**TOWN OF YARMOUTH**  
200 Main Street, Yarmouth, Maine 04096  
[www.yarmouth.me.us](http://www.yarmouth.me.us)

**PLANNING BOARD REPORT  
YARMOUTH, MAINE**

166 White's Cove Road, Yarmouth, Maine  
Shoreland Zone Permit  
Chapter 701 Article IV. Section R.  
Zaki Nashed, Applicant  
Map 3 Lot 21; LDR/SOD/RP

Prepared by: Erin Zwirko, Director of Planning & Development and Juliana Dubovsky, Assistant Planner  
Report Date: August 4, 2022; Planning Board Meeting: August 10, 2022

## Existing Site Plan

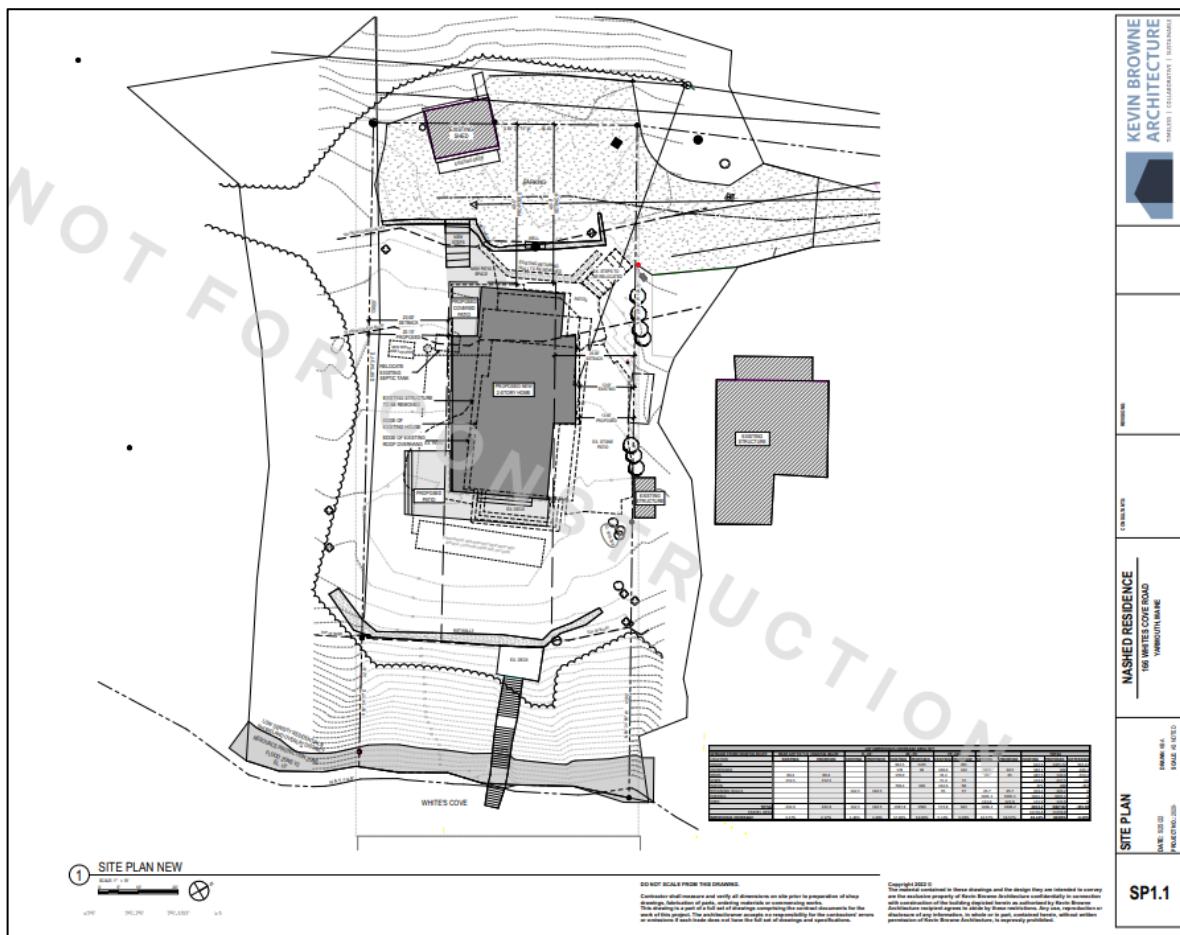
The existing two-story building is non-conforming under setbacks, lot size and width, lot coverage of non-vegetated surfaces, and height requirements. The applicant is proposing to replace the existing residential structure with a new two-story home of roughly the same footprint. Within 75 feet of the coastal bluff, the house itself is expanding in size from 922.5 square feet to 1,135 square feet. The house's proposed height of 28 feet 9 inches is a very small decrease from the existing height of 28 feet 10 inches. The application states that the proposed new footprint will be 2,441.62 square feet, which is a decrease of 345.38 ft (12%). The side yard setback on the north side is increasing from 13.61 feet to 13.65 feet. The front yard setback will increase from 40 feet to 40.5 feet, however a new set of stairs and an uncovered patio will be added within that 40.5 feet. The existing retaining wall in the front yard (west side) will also be removed. The side yard setback on the southern side will be within the required 20 feet but it is a reduction from the existing setback, which is not noted on either the existing or proposed site plan drawing.

## Proposed Site Plan

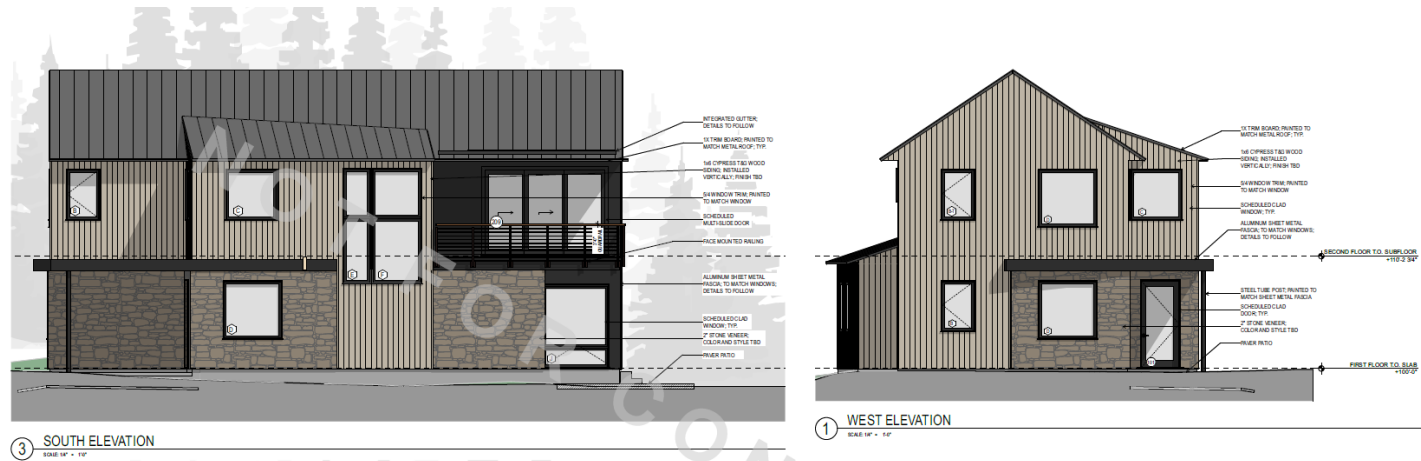
The application materials show that the area of the house that is within the 75 feet coastal bluff setback is increasing in size from 922.5 square feet to 1,135 square feet. An additional 291 square feet of the house is being added to the area of 75 feet to 100 feet of the coastal bluff. This expansion is predominantly in the southerly and westerly sides of the house. The southern side of the house will expand up to within 1 inch of the side yard setback, at 20.10 feet. A new patio on the southeastern side of the house extends into the side yard setback and beyond the footprint of the existing deck. The western expansion of the house is within the allowed front yard setback, and a new patio extends into the 40.5 feet.

# PLANNING DEPT. STUDY - 2

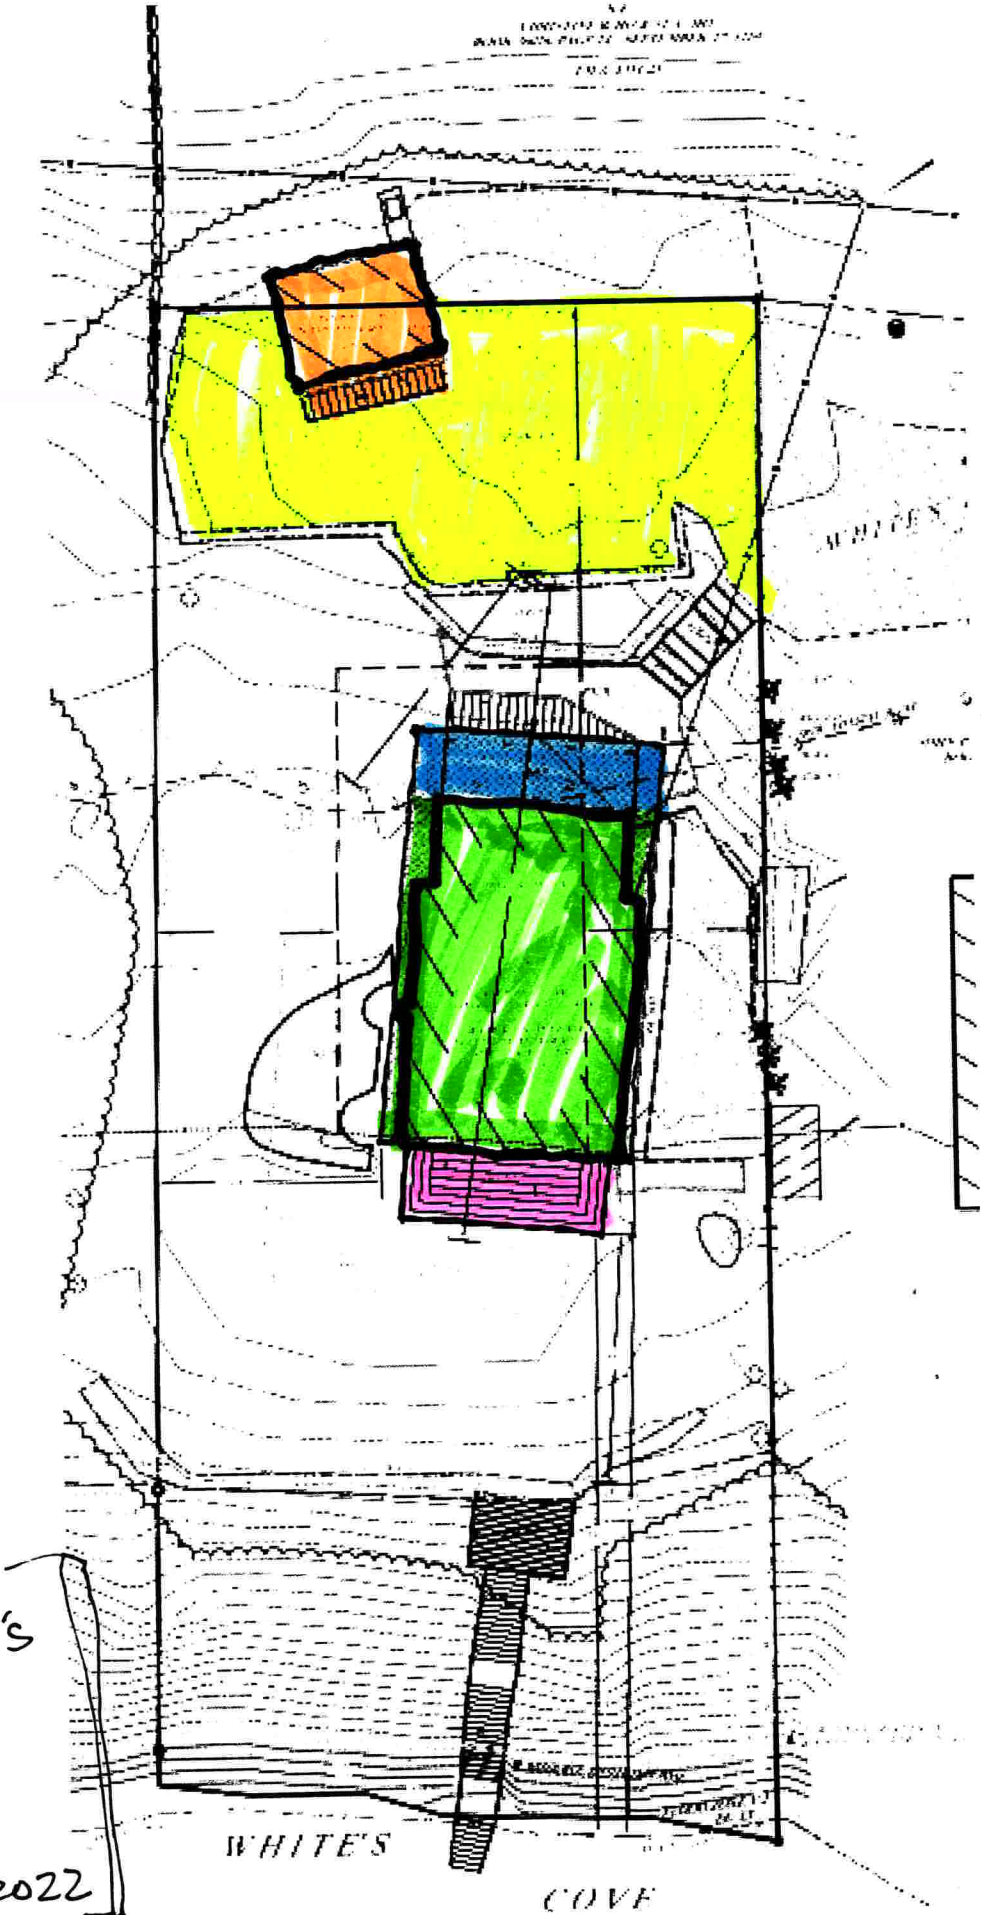
Non-conforming Regarding Shoreland Setback					
House	922.5	889	938	House Footprint - 2001 Shoreland Permit	
Deck 3	178.9	X	96	2001 Shoreland Permit - Noted as Stairs & Walkway - scaled to 4'X24', Also noted on 2005 HHE-200	
Deck 4	89.4	X	X	NO INFO - Not confirmed, Historically Shoreland access steps and docks have not been included in these calculations	
Steps	152.5	X	X	NO INFO - Not confirmed, Historically Shoreland access steps and docks have not been included in these calculations	
Patio 2	219.8	X	X	NO INFO - Not confirmed	
Patio 3	119.3	X	X	NO INFO - Not confirmed	
Retaining Wall 3	162.5	X	X	NO INFO - Not confirmed	
Gravel Patio	369.3	X	X	NO INFO - Not confirmed	
SUB TOT	2,214.2		1,034.0		
TOTAL	4,813.2		3,008.0	2001 Shoreland Permit - Noted total lot non-vegetated coverage noted as 3,008 Sq. Feet	
Total Lot Area	11,156.8		11,156.8		
Calculated % Non-Vegetated Lot Coverage	43.1%		27.0%	20% Maximum - Town will recognize 2001 Shoreland Permit 3,008 Sq. Feet (i.e. 27%) as legally existing non-conforming

# PLANNING DEPT. STUDY - 3

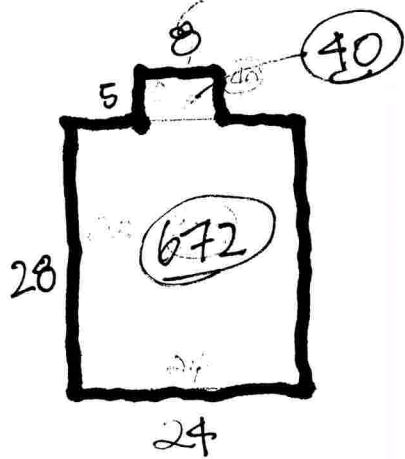
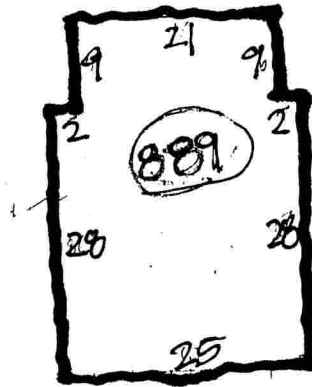
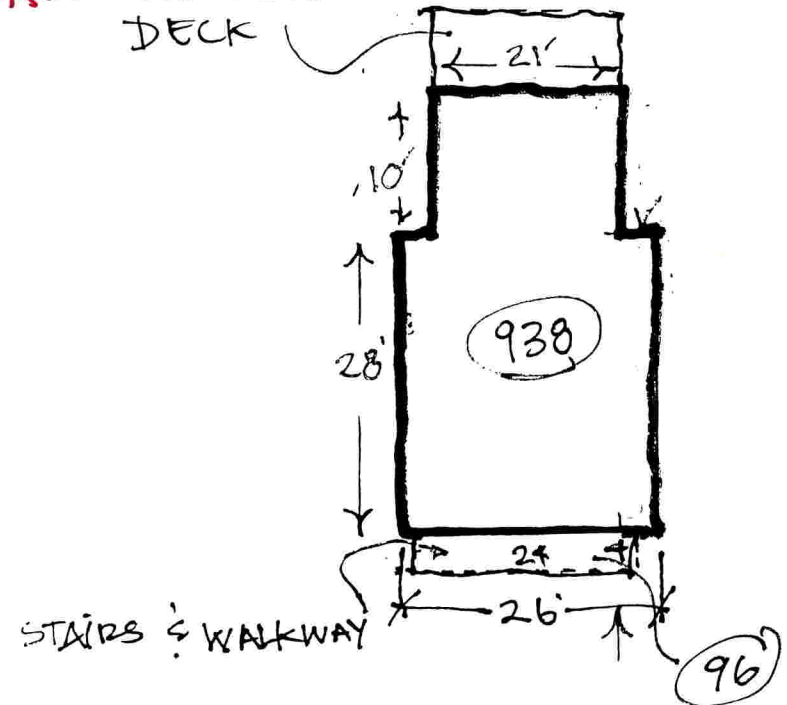
TOWN ASSUMES 1995  
FOOTPRINT IS CONSISTENT  
WITH JAN. 1, 1989 FOOTPRINT  
AND WILL BE USED AS BASIS  
FOR 30% EXPANSION.
